A. ADMINISTRATIVE REPORT & DECISION

Project Name: Cedar Ridge Short Plat

File Number: LUA17-000263, SHPL-A

Project Summary: The applicant is requesting Preliminary Short Plat approval for a proposed six (6)-lot short subdivision. The project site is 73,417 square feet (1.68 acres) and located at 13609 156th Ave NE (APNs 146340-0045 and 146340-0049). The project site is located in the Residential-4 (R-4) zoning designation. The proposed single-family residential lots range in size from 10,634 square feet to 12,019 square feet with an overall proposed net density of 3.6 dwellings per acre. Two (2) existing single-family dwellings will be removed. Additional improvements include one (1) storm drainage tract on the west boundary of the site and curb, gutter, sidewalk and planter strip along the subject property's SE 2nd Pl and 156th Ave SE abutting frontage. The application also includes a request to modify the street standards for frontage improvements along 156th Ave SE. The proposed lots will be served by existing sanitary sewer and water mains. The applicant proposes to retain four (4) of the site's 29 significant trees resulting in a required planting of 60 new caliper inches.

PRELIMINARY UTILITY PLAN

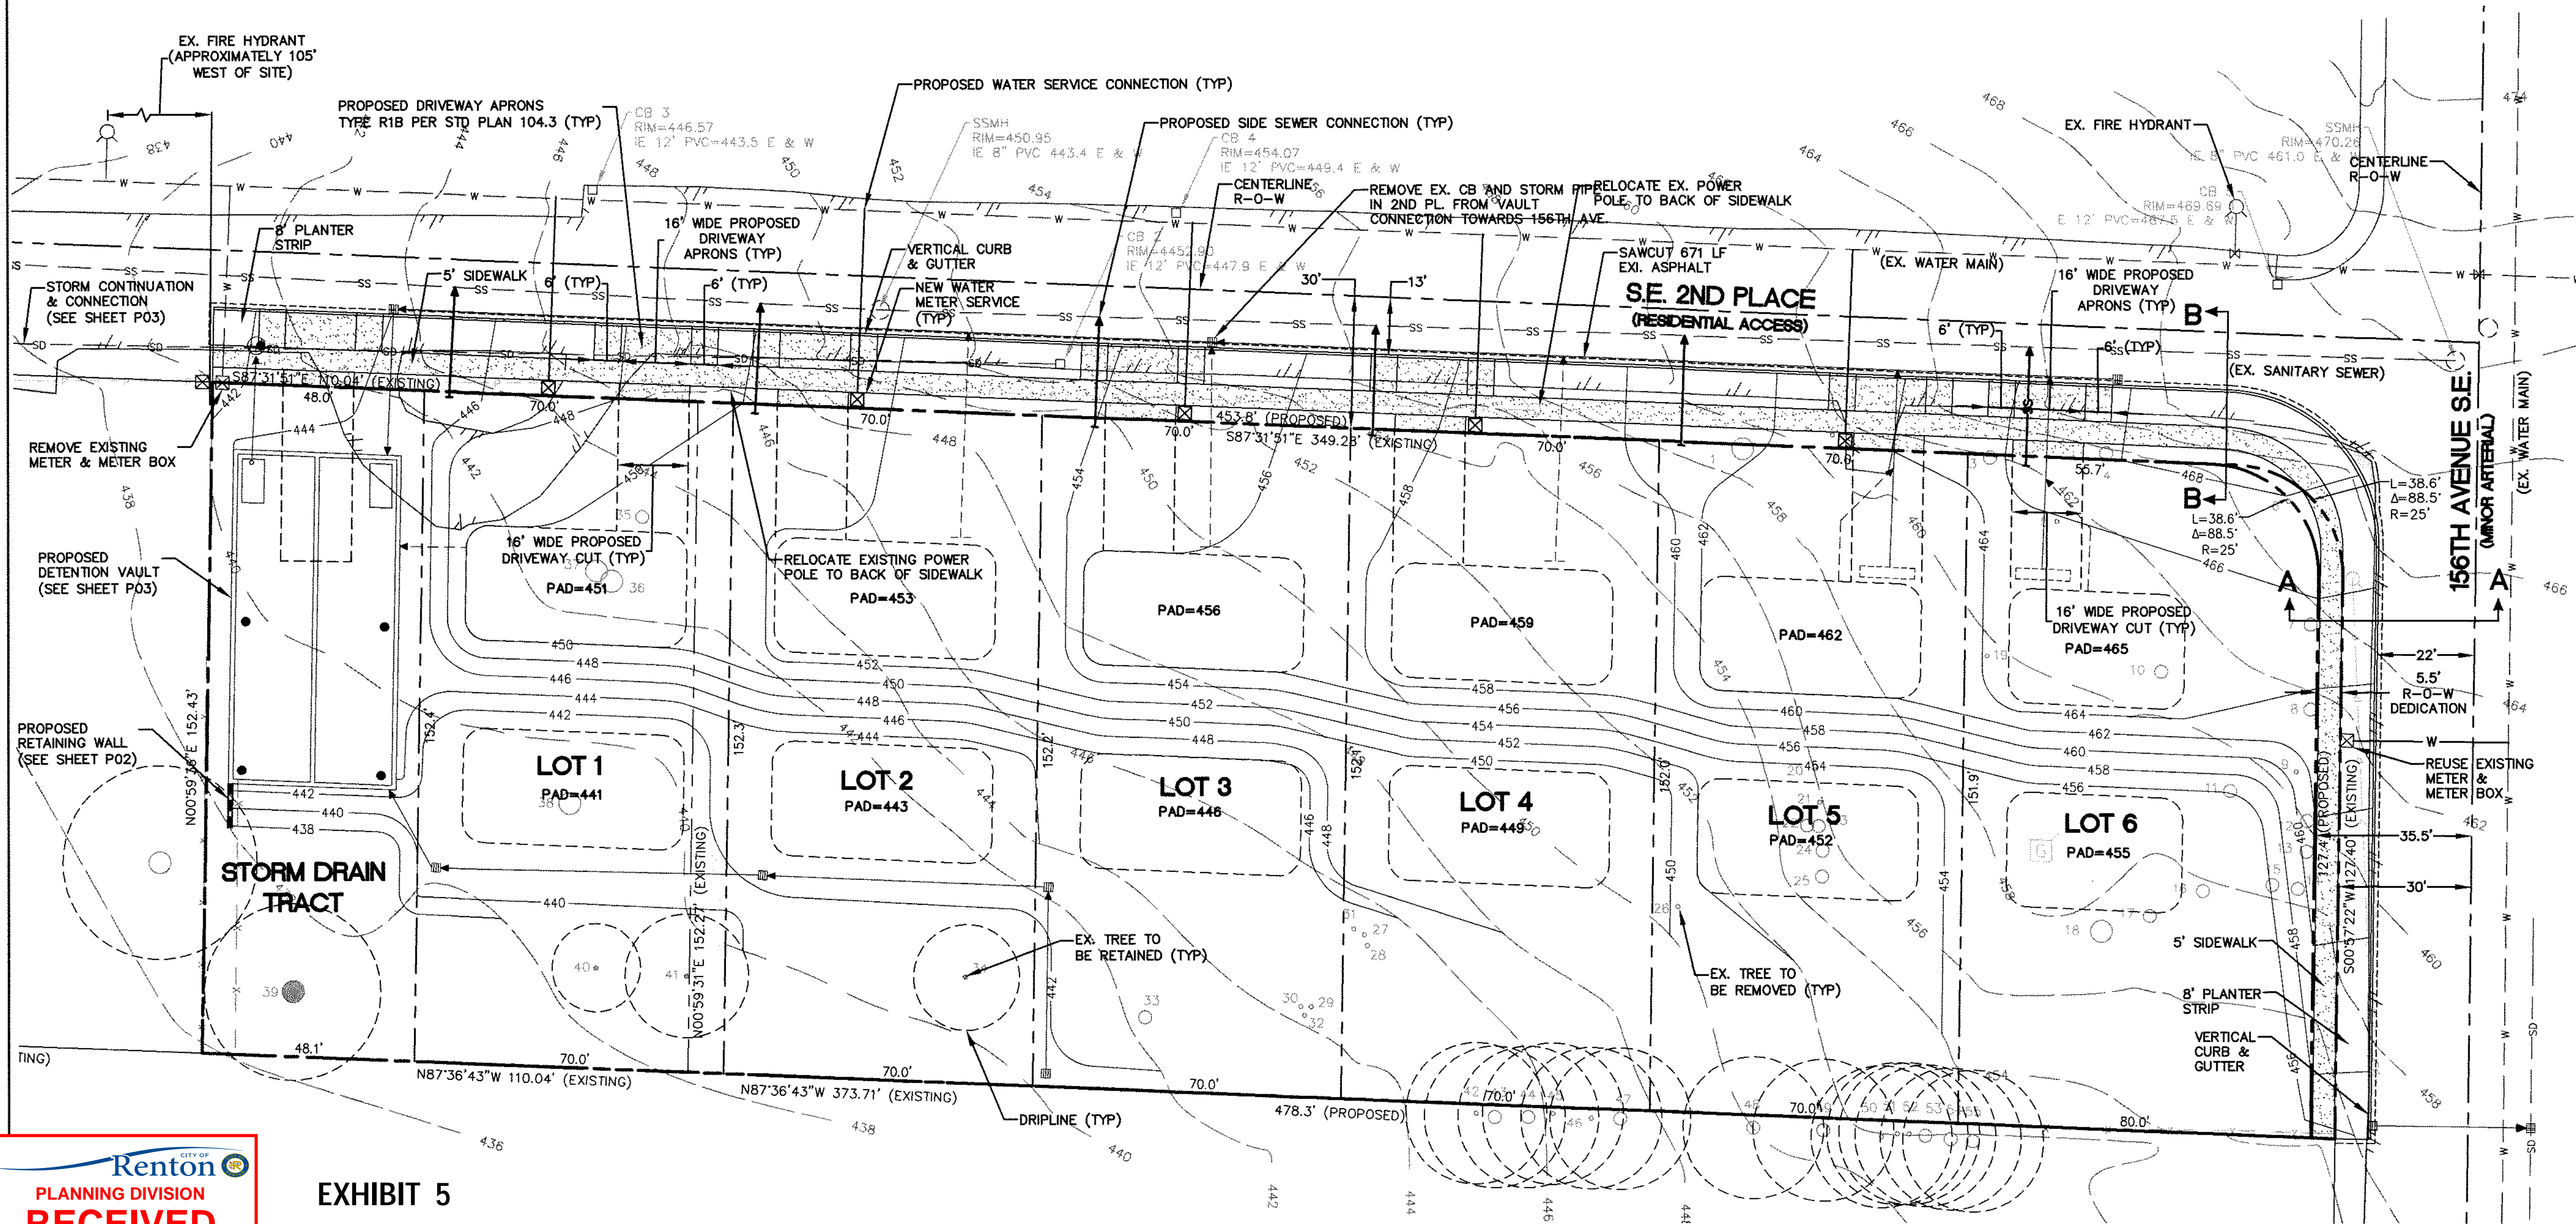
The street section for 156th Avenue SE shown on the preliminary utility plan is consistent with the corridor plan described above.

The street section for SE 2nd Place shown on the preliminary utility plan is consistent with the residential access street standards described above.

PRELIMINARY
 GRADING AND TREE
 RETENTION PLAN

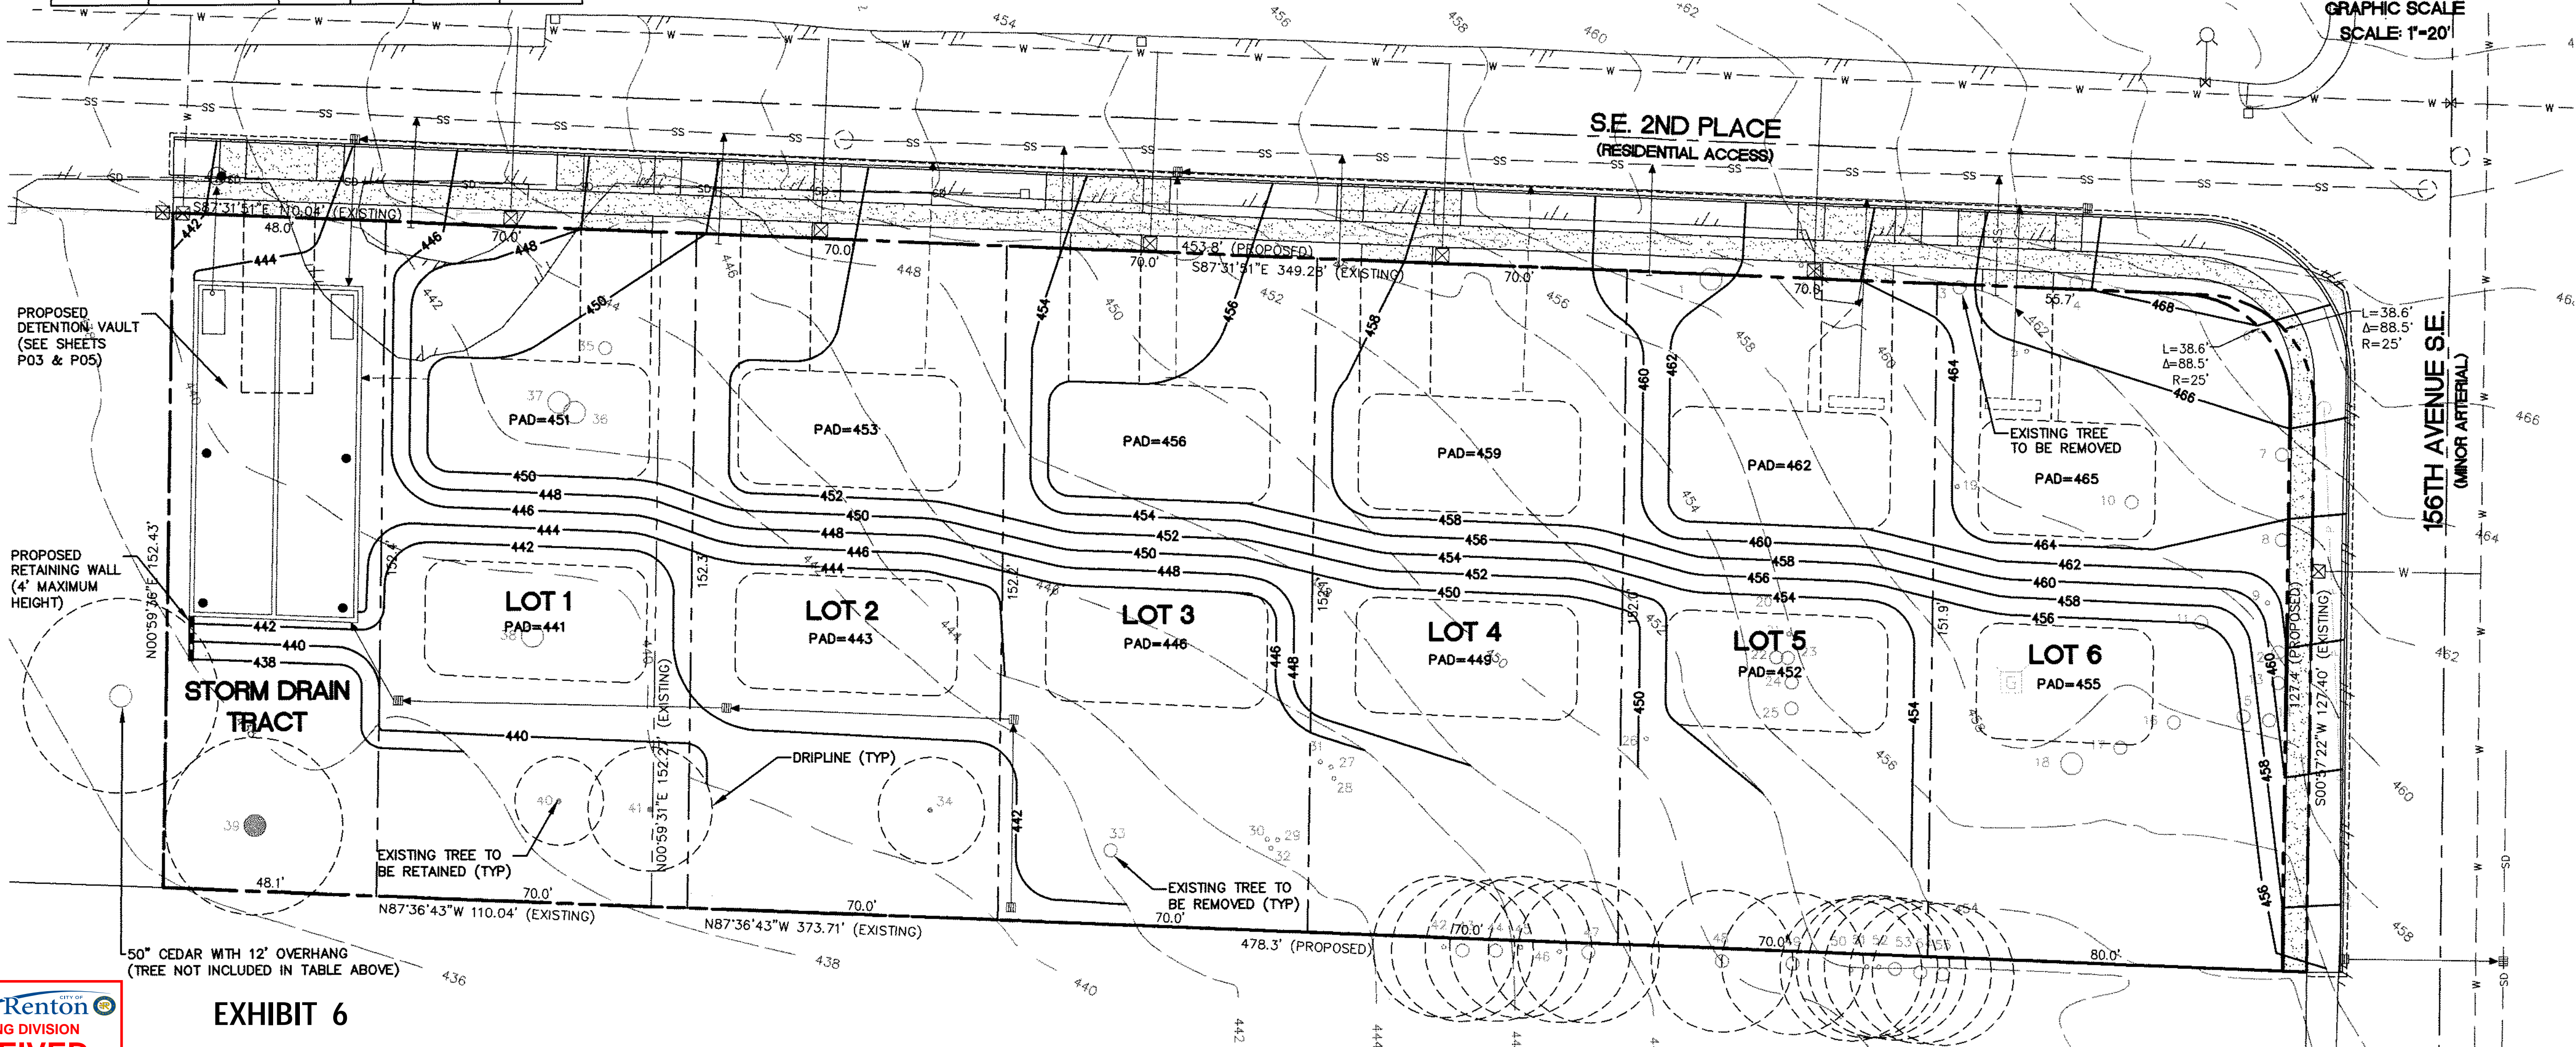
5. The applicant shall submit a revised grading plan that relocates the grading limits and the retaining wall outside of the drip line of the 50" dbh cedar tree located on the abutting western property; or the applicant shall provide evidence the abutting property owner would be in compliance with RMC 4-4-130C Allowed Tree Removal Activities. The revised grading plan or abutting property owner evidence shall be submitted with the construction permit application for review and approval by the Current Planning Project Manager prior to construction permit issuance.

6. The applicant shall provide a cut sheet with the revised grading plan that confirms the retaining wall material is composed of brick, rock, textured or patterned concrete or other masonry product that complements the proposed site development. The cut sheet and final grading plan shall be submitted with the construction permit application for review and approval by the Current Planning Project Manager prior to construction permit issuance.

SHEET TITLE:
LANDSCAPE
PLANTING
PLAN

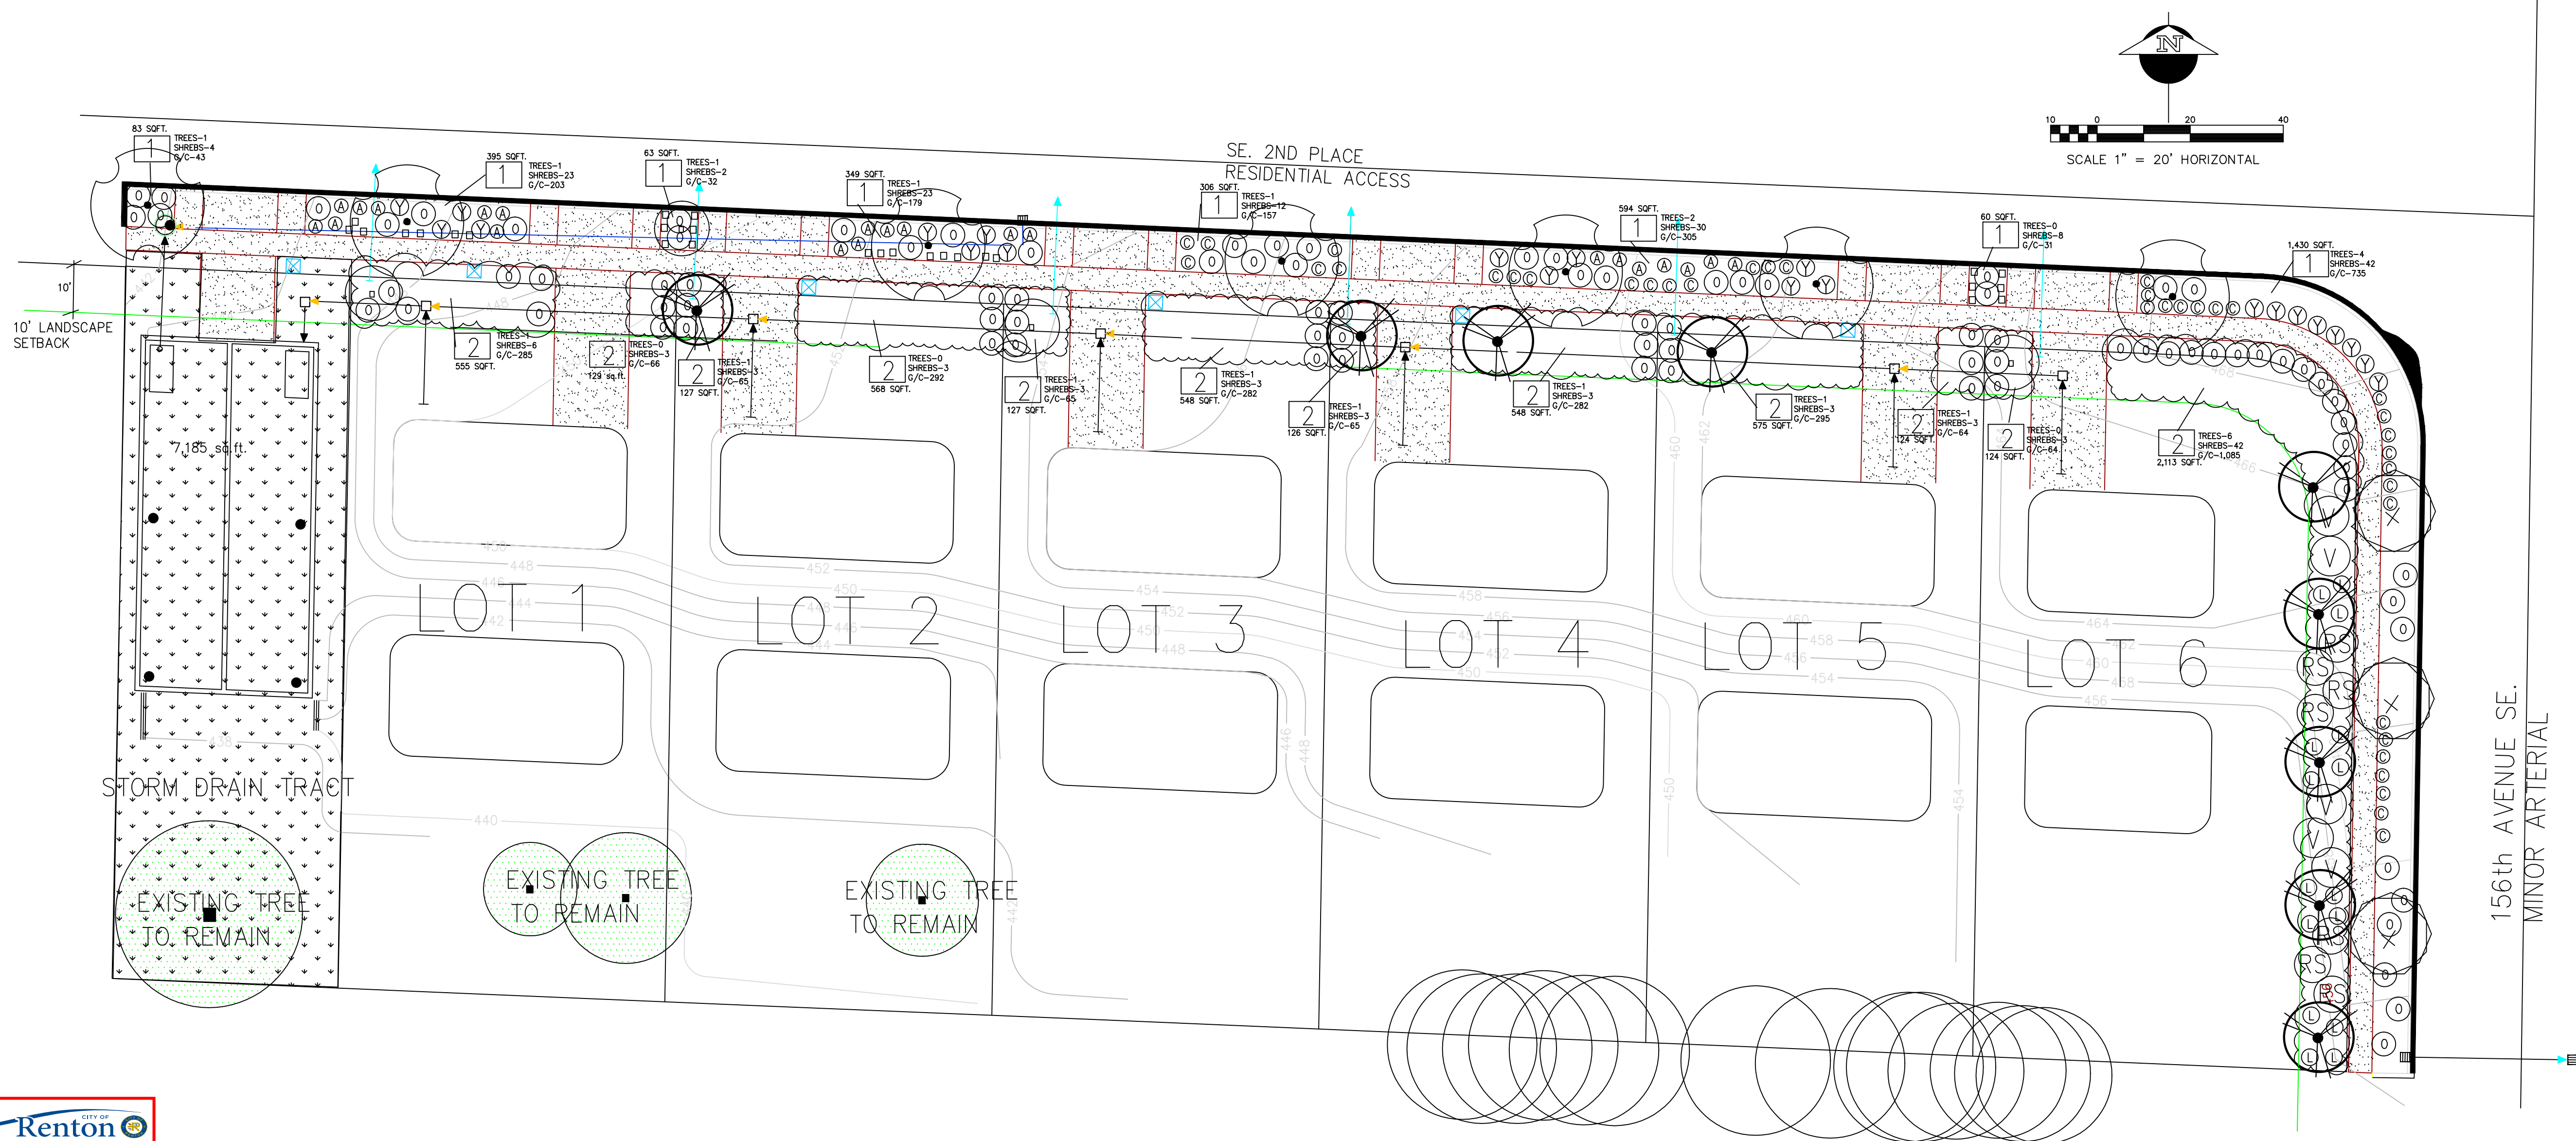
1. The applicant shall submit a final landscape plan that provides the storm drain tract with the required 15-foot landscape screen consisting of trees, shrubs, and groundcover along the SE 2nd PI frontage. The screen shall continue south along the east and west boundaries of the tract with a width and distance that adequately screens the facility from the right-of-way but not compromise the facility's function. The plan shall be submitted with the Construction Permit application for review and approval by the Current Planning Project Manager prior to construction permit issuance. The final landscape plan shall comply with the submittal requirements set forth in RMC 4-8-120D.12 Landscape Plan, Detailed.

2. Due to overhead utilities, the applicant shall submit a final landscape plan that replaces the street trees with a Small Tree variety from the City Approved Street Tree List within the planter strips. The final landscape plan shall be submitted with the Construction Permit application for review and approval by the Current Planning Project Manager prior to construction permit issuance.

3. The applicant shall submit a revised landscape plan that provides the remaining 28 caliper inches required to meet the tree replacement ratio. Replacement trees shall be prioritized for planting in available space within the storm drain tract; second priority - planter strips; and last priority - individual lots. The detailed landscape plan shall be submitted with the construction permit application for review and approval by the Current Planning Project Manager prior to construction permit issuance.

4. The applicant shall submit a revised landscape plan that provides additional trees in Lots 1-5 resulting in each lot containing a minimum of four (4) significant trees, to meet the tree density calculations. The detailed landscape plan shall be submitted with the construction permit application for review and approval by the Current Planning Project Manager prior to construction permit issuance.
